CHANGE ORDER

Project Name: Boutwell Road Lake Worth Park of Commerce – Phase II

Change Order Number: 03

Issue: Installation of new swale structure

line of sight from proposed drainage location to new S-54 Drainage location below stop sign

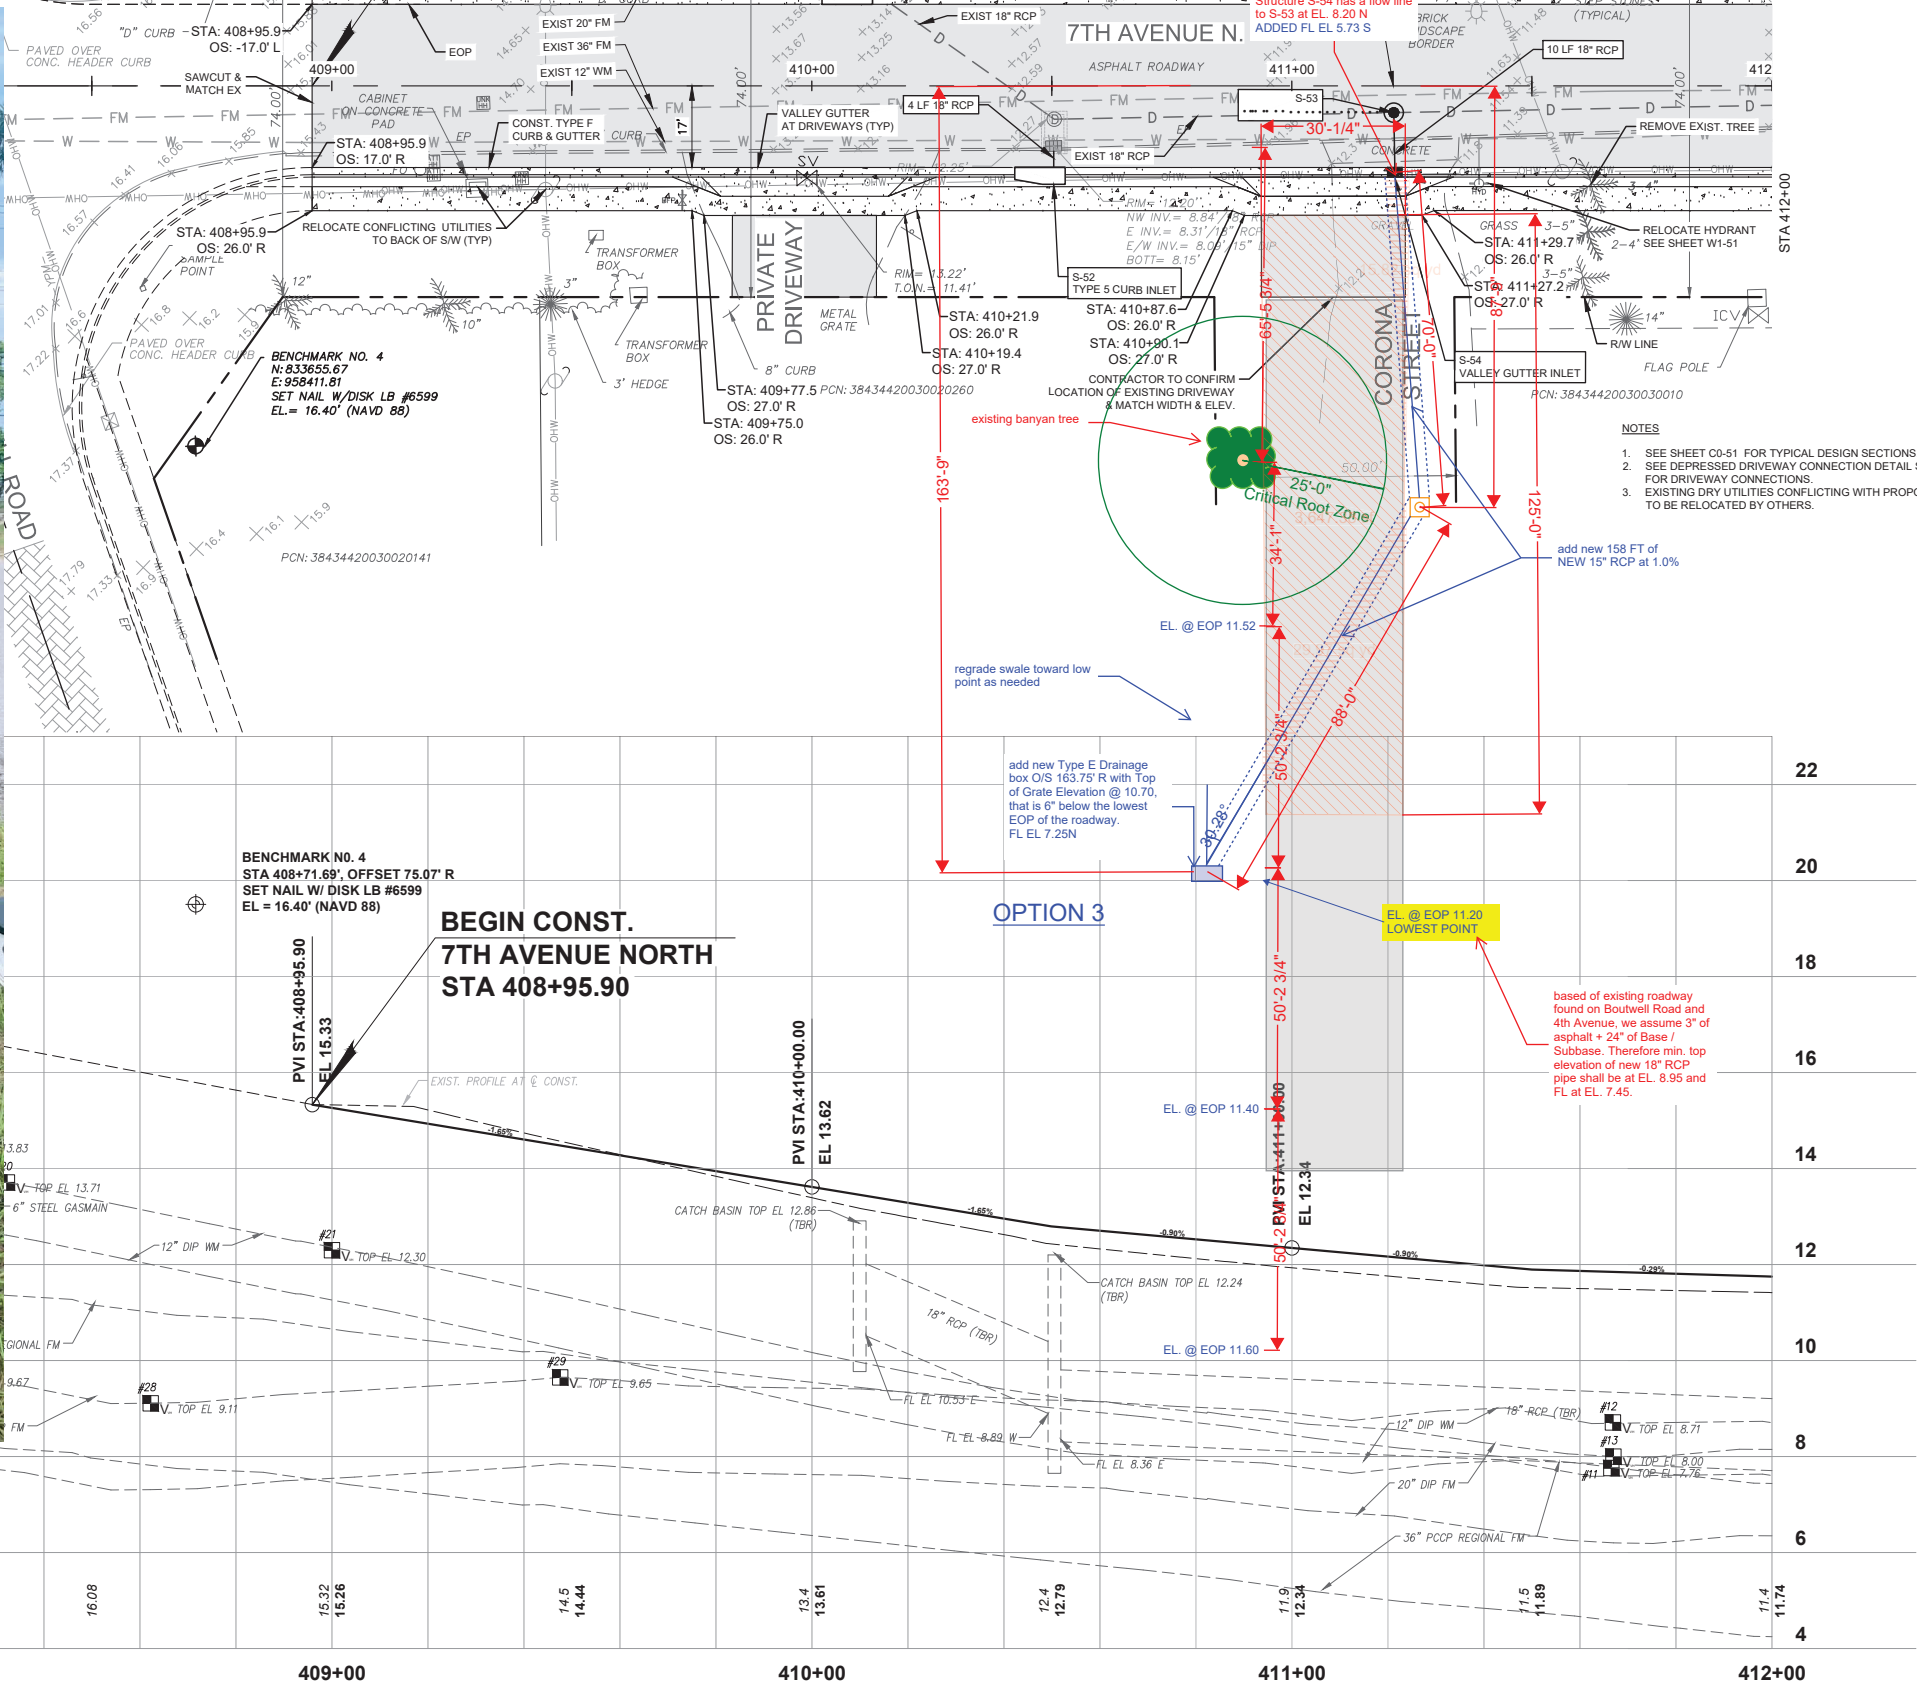
To repair the current swale drainage overflow at Corona St. just south of 7th Ave., City of Lake Worth Beach decided to connect a new swale structure to the new S-54 structure. Therefore, the City of Lake Worth Beach negotiated with the Contractor for the additional costs to install new swale structure, connecting pipe work and restoration.
